Application 10/501031

Response to Office Action dated 01/19/2007

Amendments to the Drawings:

Inventor: NAKANO
 Docket No.: 8279.758USWO
 Title: EMULSIFICATION/DISPERSION SYSTEM USING MULTISTAGE
 DEPRESSURIZATION MODULE AND METHOD FOR PRODUCING
 EMULSIFIED/DISPERSED LIQUID
 Attorney Name: Curtis B. Hamre
 Phone No 612-455-3802
 Sheet 3 of 13

Fig.3

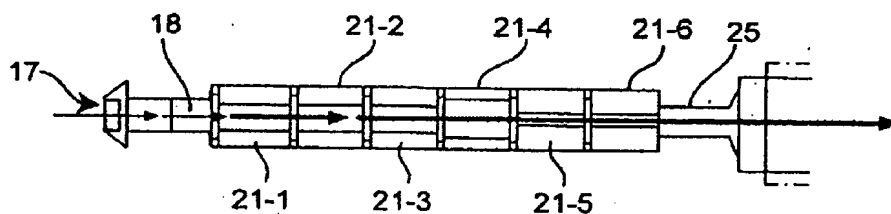
The attached sheets of drawings include changes to Fig. 3 and to Fig. 14. The first sheet, which includes Fig. 3, Fig. 5 and Fig. 8, replaces the original sheet including Fig. 3, Fig. 5 and Fig. 8. In Figure 3 the title has been changed from MULTISTAGE DEPRESSURIZATION MODULE to MULTISTAGE EMULSIFICATION/ DISPERSION MODULE. The second sheet, which includes Fig. 14, replaces the original sheet including Fig. 14. In Figure 14, reference numeral 480 has been changed to 400.

MULTISTAGE EMULSIFICATION/DISPERSION MODULE
~~MULTISTAGE DEPRESSURIZATION MODULE~~
